Probabilistic Risk Assessment Input to Decommissioning Requirements

NRC/Industry/Public Workshop

Risk-Informed Basis for Decommissioning Exemption Guidance

July 15-16, 1999

Figure 3.3-1 Comparison of Spent Fuel Time Line for Loss of Cooling Events

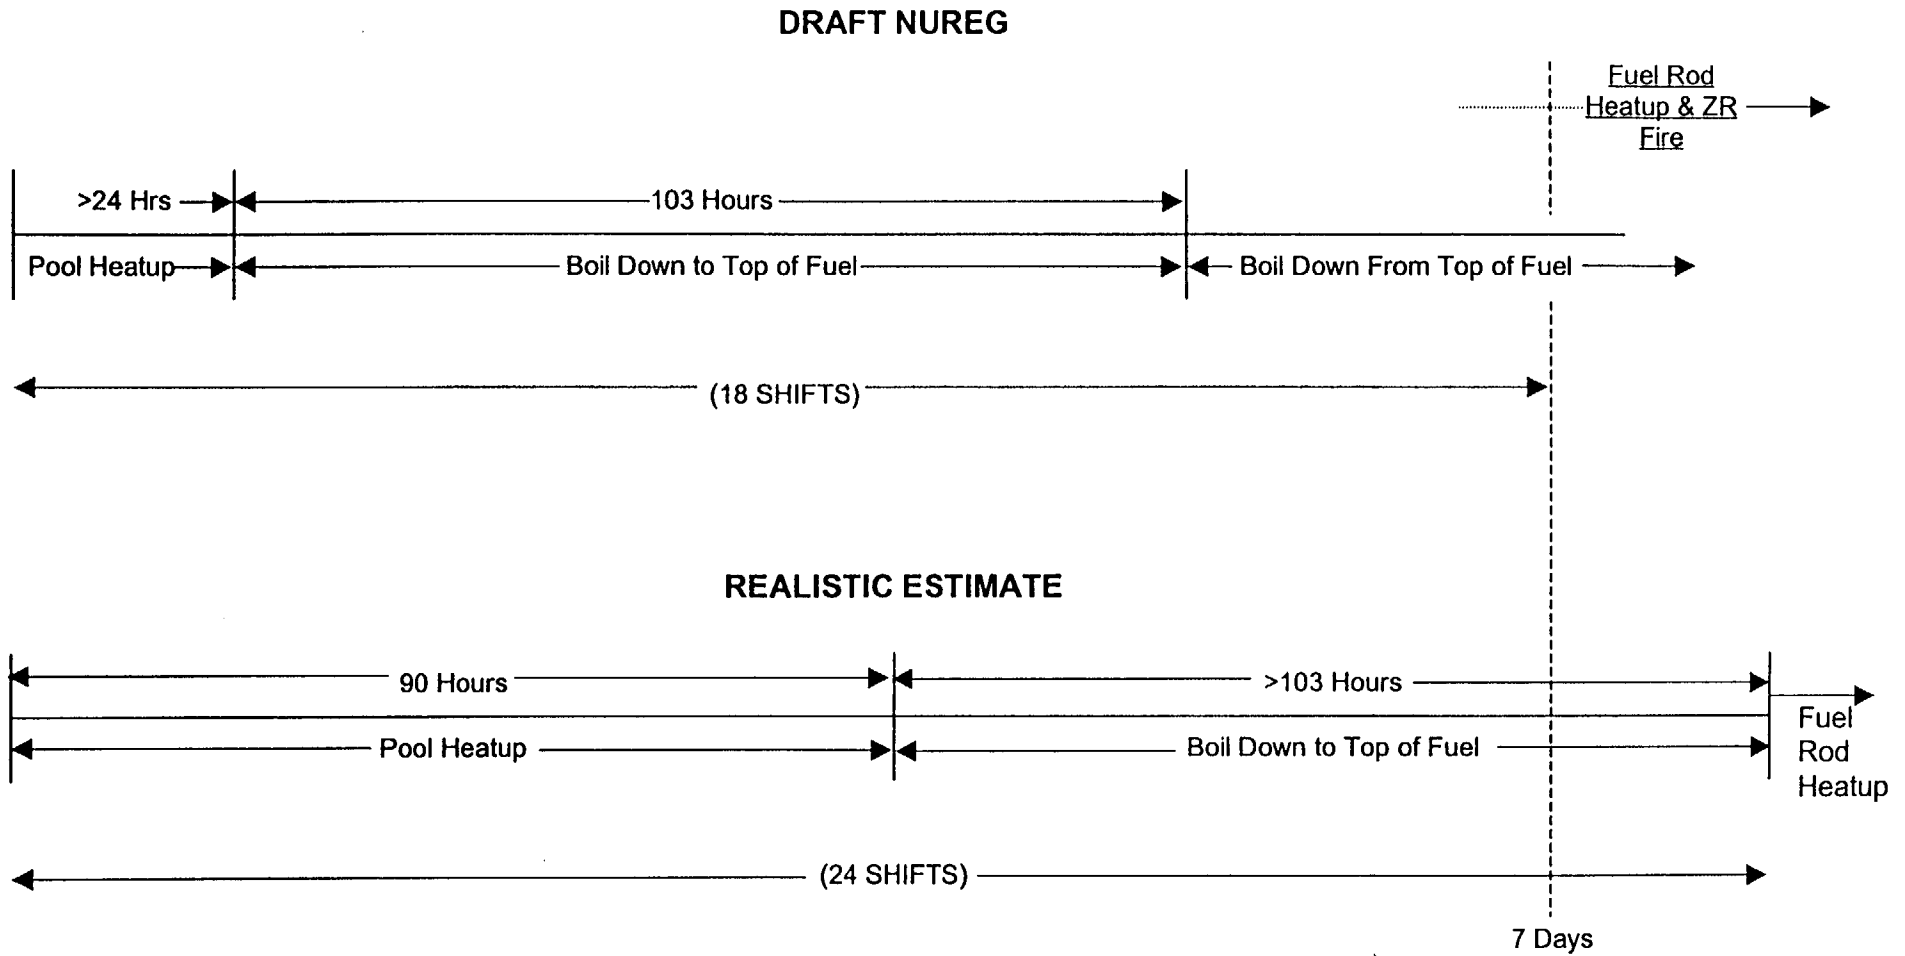
The two orders of magnitude change in perceived frequency appears to be strictly a conservative bias introduced

Table 2.1-1
KEY TEMPERATURES IN THE ASSESSMENT OF
ZIRCONIUM IGNITION & RUNAWAY OXIDATION

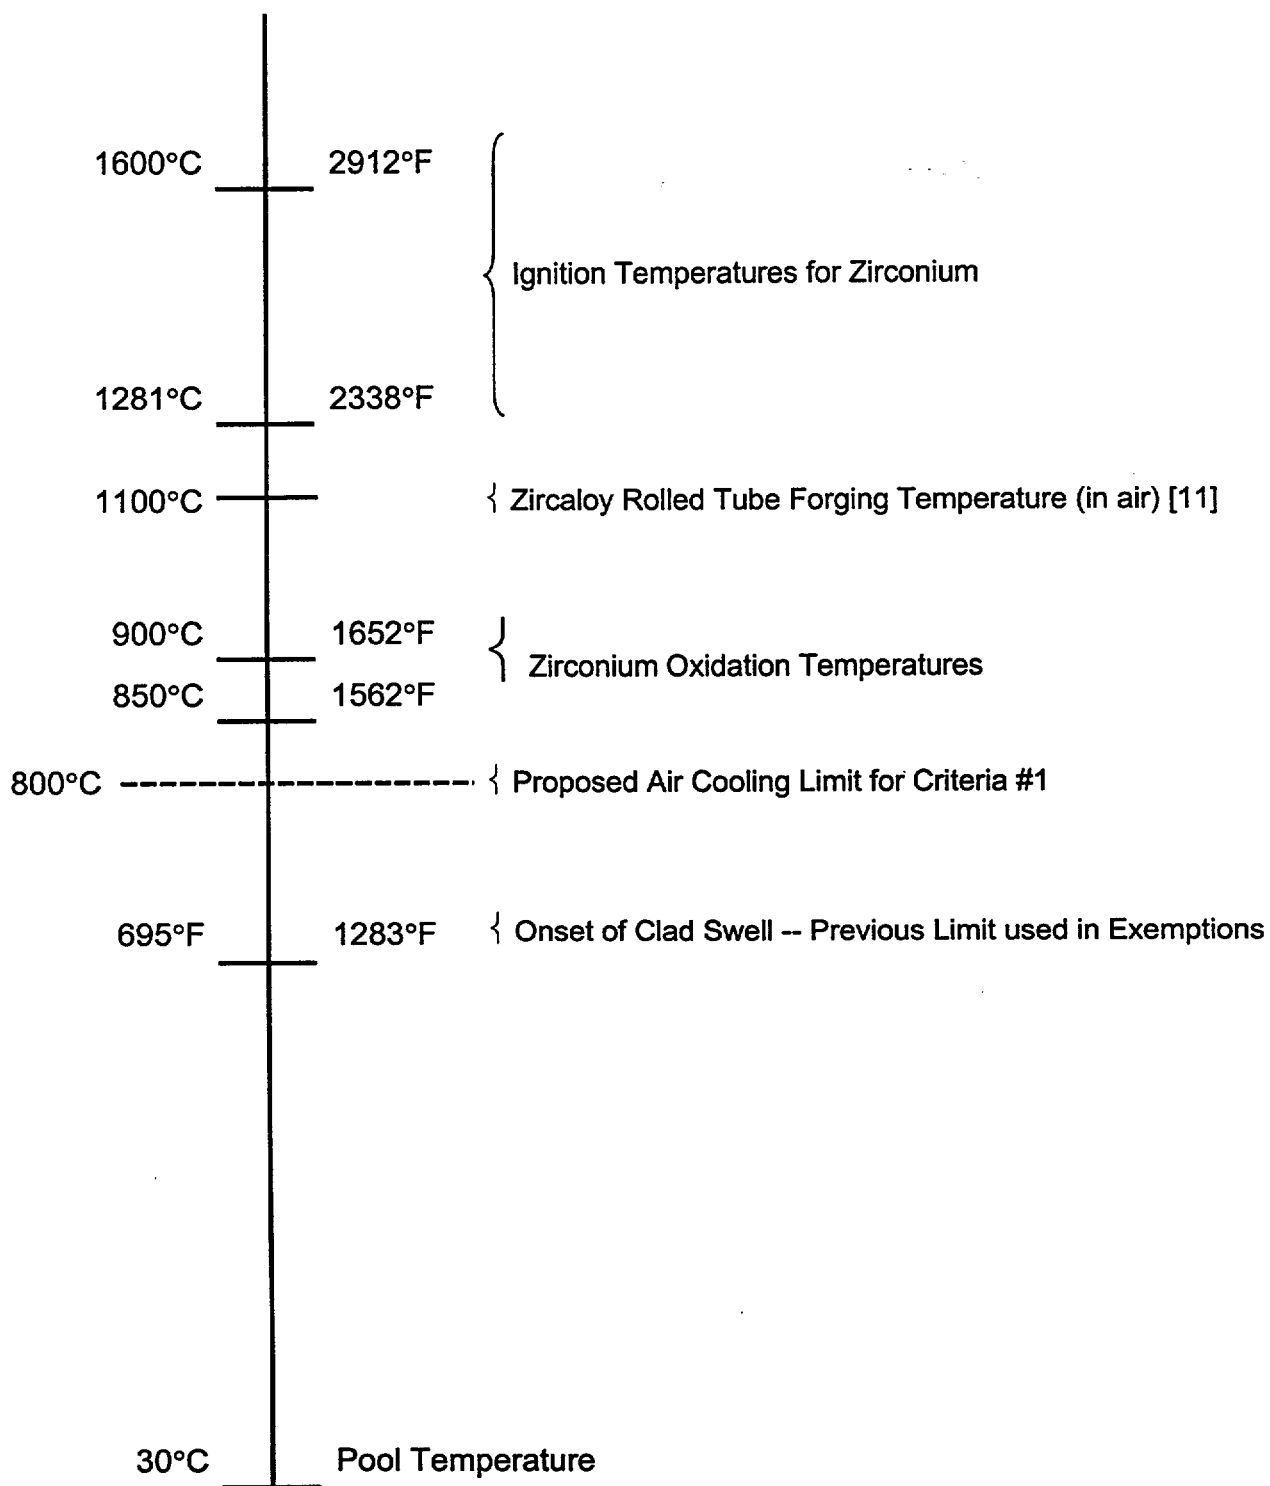
“The oxidation temperature reported by SNL was the onset of oxidation, but not the temperature at which rapid, runaway oxidation or ignition occurs”

Nevertheless 800°C is used despite references indicating that Zircaloy ignition is >1600°C.

COMPARISON OF POINT ESTIMATES

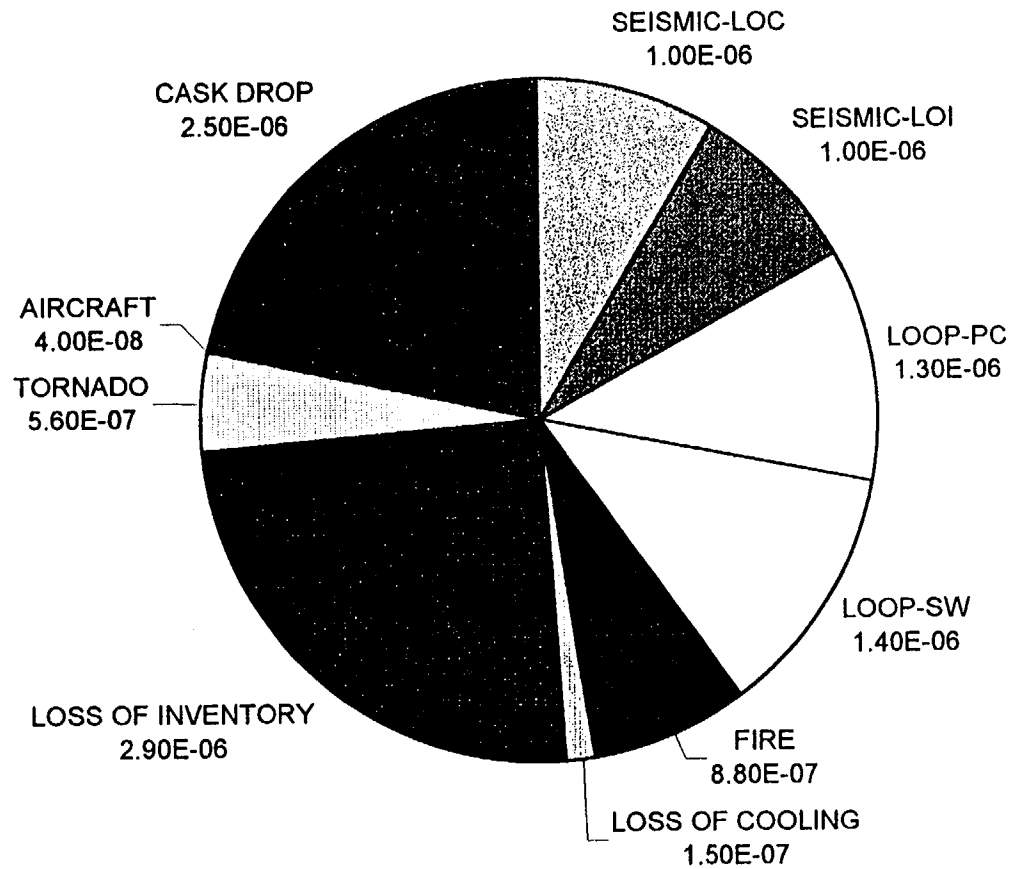
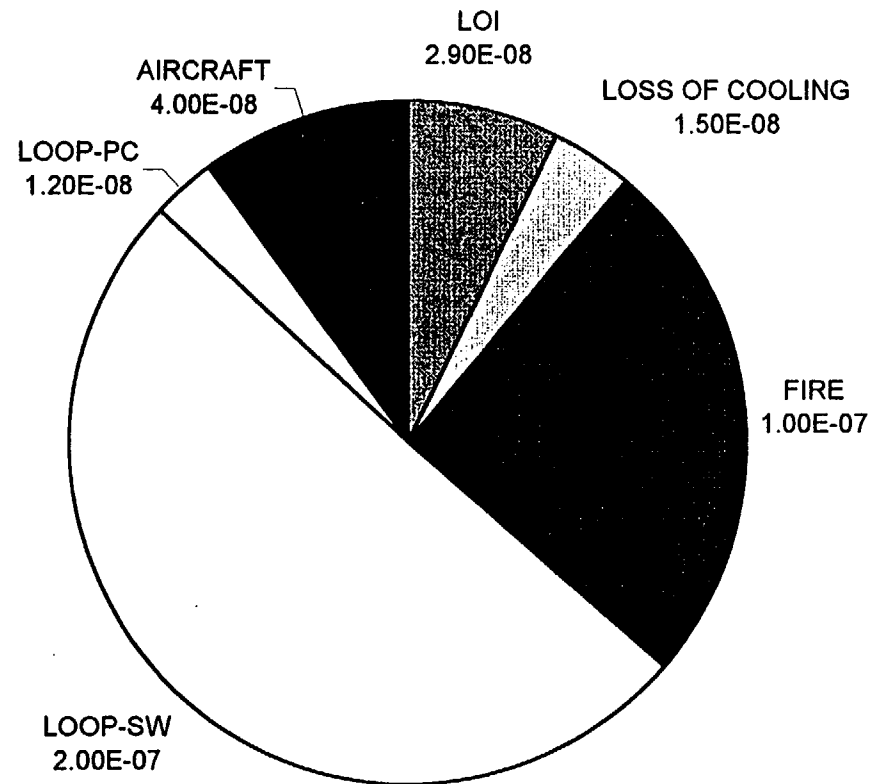
**DISTRIBUTION OF CONTRIBUTORS TO FREQUENCY OF FUEL UNCOVERY (FFU) FROM
DRAFT NUREG
(Case I Total FFU=1.2E-5/yr)**

**DISTRIBUTION OF CONTRIBUTORS TO FREQUENCY OF FUEL UNCOVERY (FFU) FROM
BEST ESTIMATE CALCULATION
(Case I Total FFU=4E-7/yr)**
